**ON-SITE SEWAGE DISPOSAL SYSTEM
HOWARD COUNTY HEALTH DEPARTMENT
BUREAU OF ENVIRONMENTAL HEALTH**

SUBDIVISION: Sollers Property LOT NUMBER: 4

ADDRESS: 17280 Old Frederick Rd. PROPERTY OWNER: Altieri Altieri Enterprises, Inc.

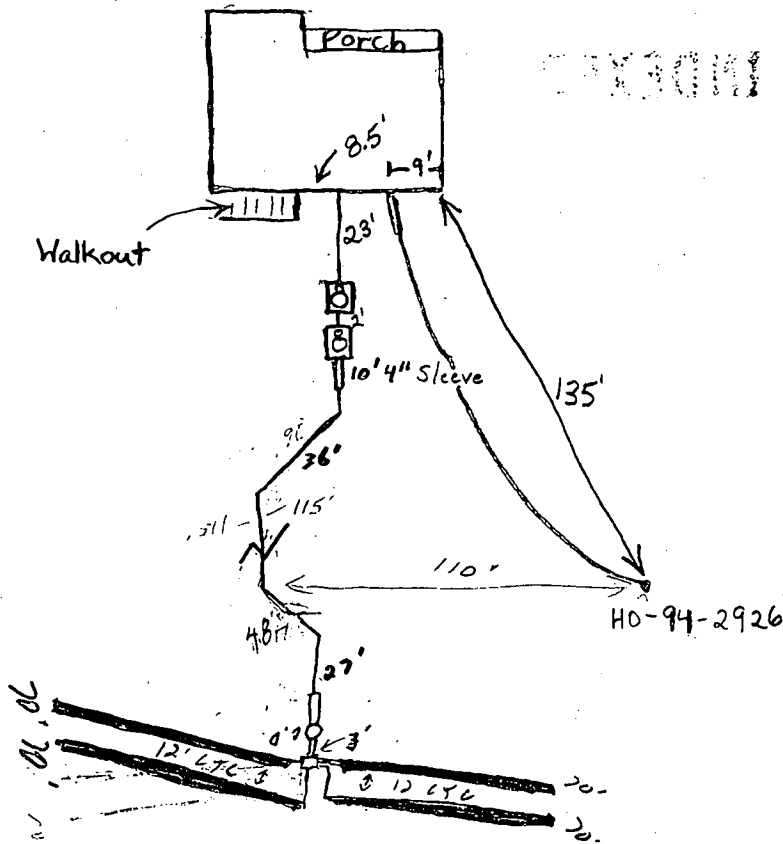
PRE-CONSTRUCTION INSPECTION: Old Frederick Road 1/30/02 To run 70' trenches in both

directions from center of easement (BB)

INSPECTION COMMENTS: 1/30/02 Tanks set. O.K. to backfill around them (BB)

1/31/02 Told contr. not to put cleanouts on pressure line. O.K. to cover all work. Pump & Alarm tests needed (SC)

4/2/02 Cleanout by D.B. has been run over, dug up to repair. Pump & Alarm tests OK (SC)
